# PD Modification Application: MM 23-0951

**Development Services Department**

#### **1.0 APPLICATION SUMMARY**

2.5 Proposed Site Plan (partial provided below for size and orientation purposes. See Section 8.2 for full site plan)

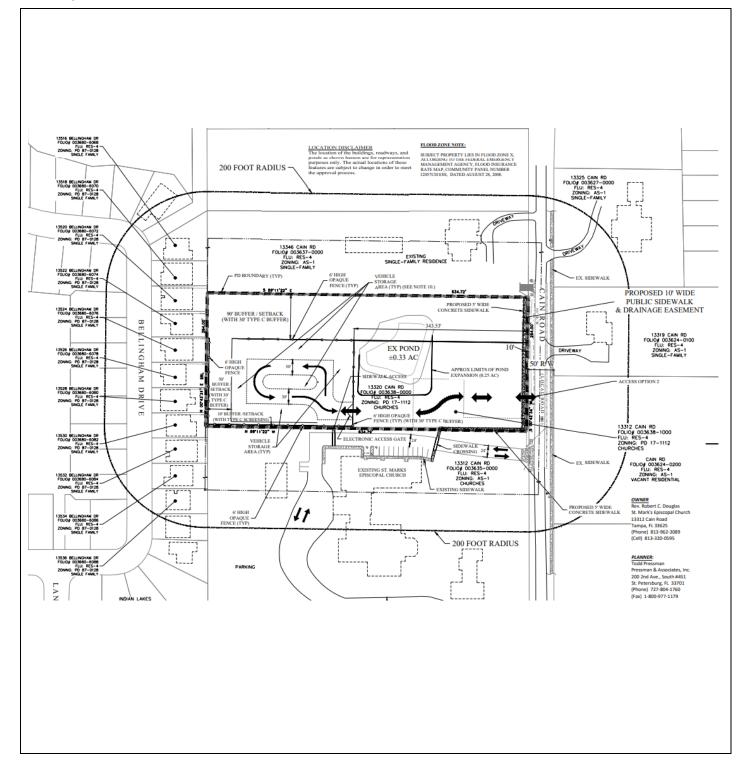
The proposed modification would allow open storage adjacent to residential to the north, west and to the east across Cain Road. To the south it would be adjacent to a church. This would introduce a high intensity commercial use in proximity to residential properties. In addition, the applicant is requesting variations to the site design to allow only a six-foot fence and natural growth screening instead of the required masonry wall and Type "C" Screening. This would not provide adequate screening from residential uses due to possible noise and disruptions. The applicant has offered restrictions to mitigate compatibility concerns, such as adding Operating hours of 6am to 10 pm and low projection, non-glare type lighting. Staff does not find the restrictions adequate to mitigate the compatibility concerns of residents.

#### 6.0 ADDITIONAL INFORMATION AND/OR GRAPHICS

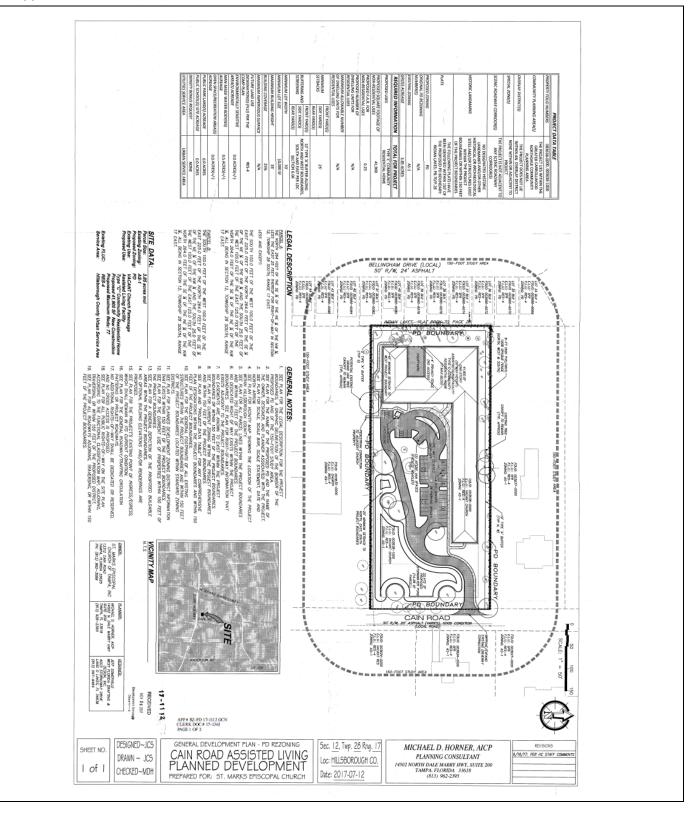
The applicant has requested four PD Variations to LDC Section 6.06.06.

1. A 30-foot-wide buffer with Type C screening is required along the west property line where abutting the PD zoned residential property.

The applicant is requesting a variation from 6.06.06 to allow natural growth as screening where it exceeds code requirements and a 50' buffer and type "a" screening for the use of a 6' opaque fence in place of a masonry wall.

2. A 30-foot-wide buffer with Type C screening is required along the north property line where abutting the AS-1 zoned residential property.

The applicant is requesting a variation from 6.06.06 to allow natural existing growth as screening where it exceeds code requirements and type "a" 6' opaque fence in lieu of a masonry wall and 90' buffer.

3. A 30-foot-wide buffer with Type C screening is required along the east property line where adjacent to the AS-1 zoned residential property.

The applicant is requesting a variation from 6.06.06 to allow natural existing growth as screening where it exceeds code requirements and type "a" 6' opaque fence in lieu of a masonry wall and 360' mol buffer.

4. A 30-foot-wide buffer with Type C screening is required along the south property line where abutting the AS-1 zoned institutional property.

The applicant is requesting a variation from 6.06.06 from the buffer and screening along the South property line, as required, to provide a type "a" screening of a 6' opaque wood fence in place of a masonry wall, with a 10' buffer where a 30' buffer is required and C type landscaping for the first 220' from the western property line running eastward along the southern property line.

Staff objects to these PD variation requests. This would not provide adequate screening from residential uses due to possible noise and disruptions.
